SUBJECT: CHANGES TO ADMINISTRATIVE CONTROLS SECTION OF TECHNICAL SPECIFICATIONS (TAC 56027, 56028, 56029)

Re: Browns Ferry Nuclear Plant Units 1, 2, and 3

The Commission has issued the enclosed Amendments Nos. 138, 134, and 109 to Facility Operating Licenses Nos. DPR-33, DPR-52, and DPR-68 for the Browns Ferry Nuclear Plant, Units 1, 2, and 3, respectively. These amendments are in response to your application dated September 27, 1984 as supplemented January 17, June 2, and December 10, 1986 (TS-201). Minor changes were made to proposed Specifications 6.5.1.6.b and k, 6.5.3.1 and 6.8.1.1 to clarify the Specifications. These changes were discussed between the Office of Special Projects, Project Managers and Mike May (licensee) on September 8, and September 11, 1987, and accepted by the licensee.

Figure 6.2-1 Offsite Organization for Facility Management & Technical Support

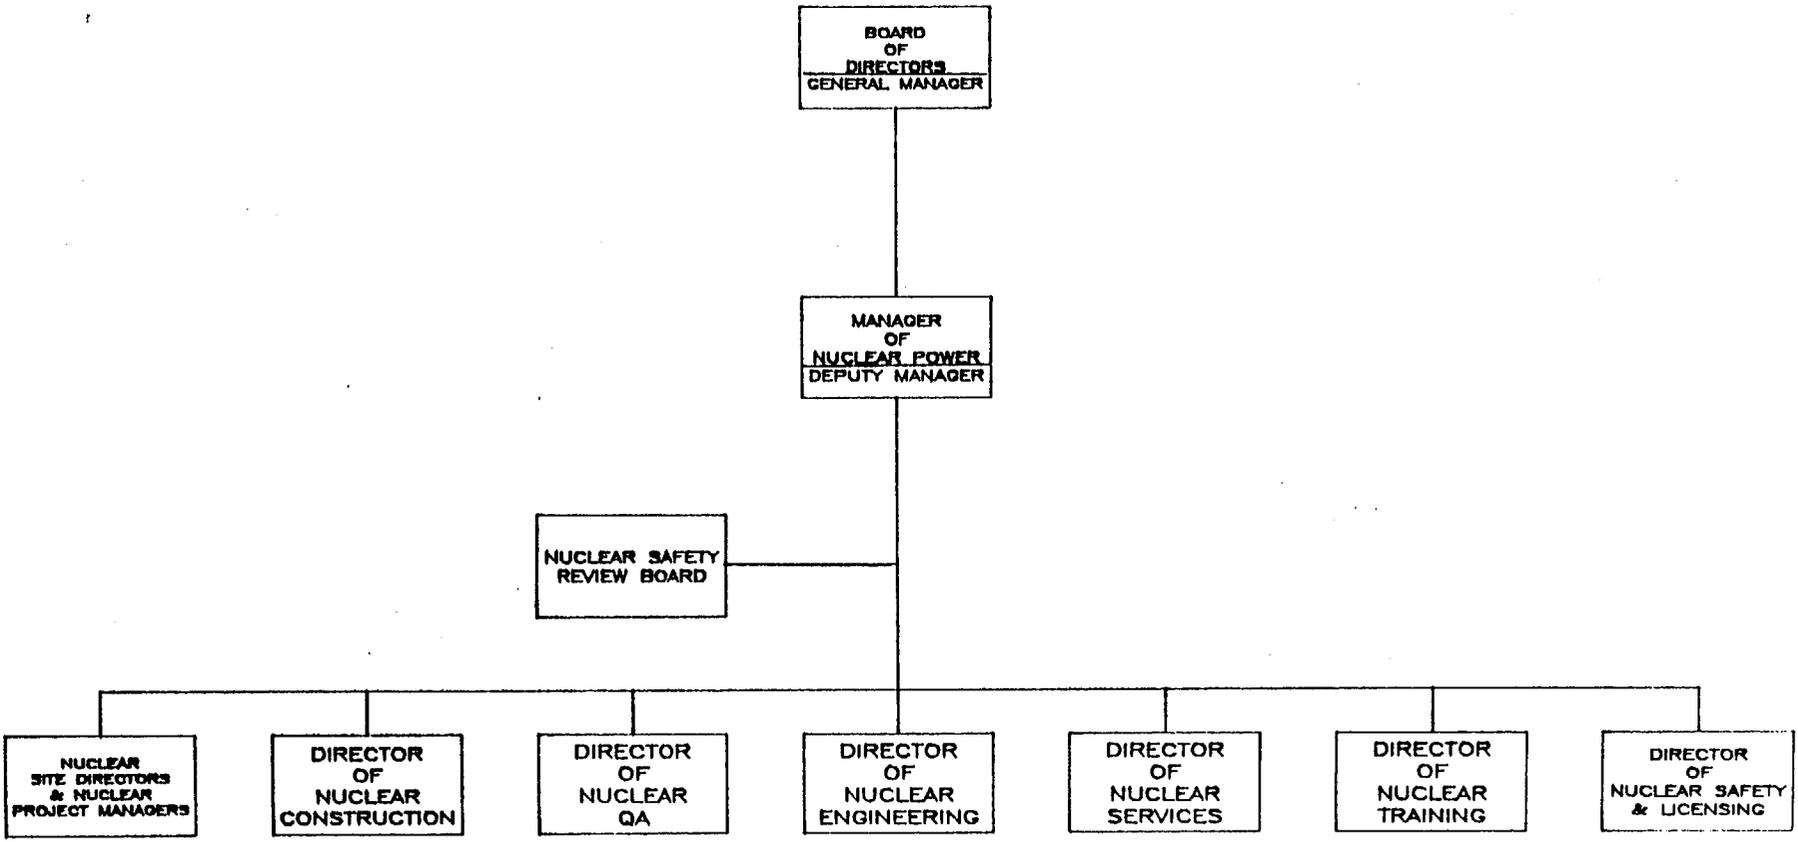
2.3 Revisions to the Offsite Organization Chart, Figure 6.2-1

Figure 6.2-1 has been revised to reflect the TVA corporate offsite nuclear organization for facility management and technical support. The corporate level changes represent a restructuring of the corporate offsite organization to provide for centralized direction and control of nuclear activities. Each of the offsite corporate departments shown in Figure 6.2-1 will be responsible for direct support of the sites in their areas of responsibilities. The TVA corporate organization was developed so that support to each of the sites follows clear lines. The functional alignment of departments within corporate is paralleled at the plant sites (including Browns Ferry).

The staff considers this functional alignment of departments and standardizations of TVA an improvement over the organization presented in the existing Browns Ferry TS. The corporate organization is acceptable, since it provides for management attention to and support of the Browns Ferry nuclear program, meets the acceptance criteria of Section 13.1.1 and 13.1.2 of the Standard Review Plan (SRP) and is consistent with the TVA organization presented in the revised TVA Corporate Nuclear Performance Plan which was approved in NUREG-1232, Volume 1.

**FIGURE 6.2-2
 FACILITY ORGANIZATION**

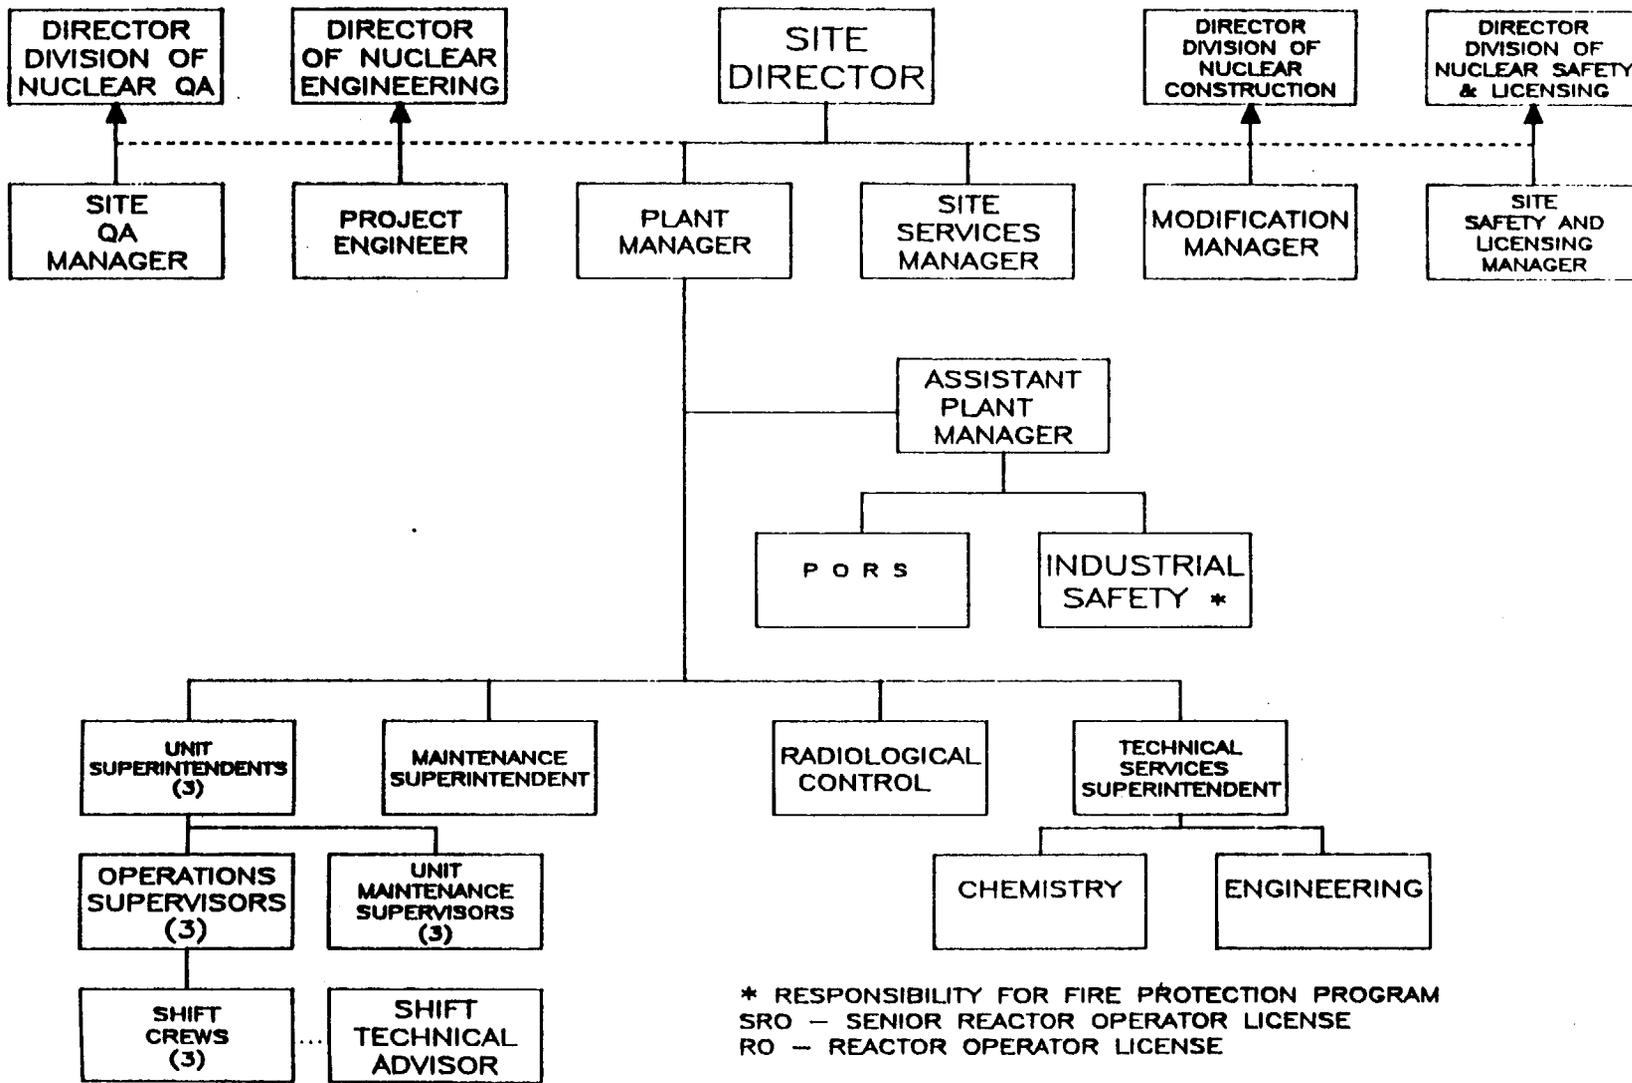
2.4 Revision to the Facility Organization Chart, Figure 6.2-2

Figure 6.2-2 has been revised to reflect the new site organization at the Browns Ferry Nuclear (BFN) Plant as detailed in the latest revision of the Browns Ferry Nuclear Performance Plan (BFNPP), submitted to NRC on July 1, 1987. The BFN site support organizations have been reorganized into functional departments that generally parallel the functional departments in the headquarters of the Office of Nuclear Power. The BFNPP describes the plan for providing management control and performing specific actions to correct past problems at BFN. Specifically, the BFNPP outlines the management approach to overcoming past problems and improving regulatory performance at the BFN. This TS change revises the organization chart in the TS to be consistent with the organization necessary to carry out the improvements specified in the BFNPP.

The Plant Manager is responsible for conducting day-to-day plant operation in compliance with licensing and regulatory requirements. A plant management organization has been implemented with a unit superintendent assigned to each of the units. As a result of the reorganization, the Plant Manager is free to concentrate his attention on the actual conduct of plant operations.

In conclusion, Figure 6.2-2 represents the BFN organization which (1) reflects an increase in staffing, (2) provides a higher level of management control at the site, (3) shows improved management involvement in plant operations, (4) has distinct functional areas that are separately supervised, (5) meets the acceptance criteria of Section 13.1.2 of the SRP, and (6) is consistent with the BFN organizational structure presented in the BFNPP. Therefore, Figure 6.2-2 is acceptable.
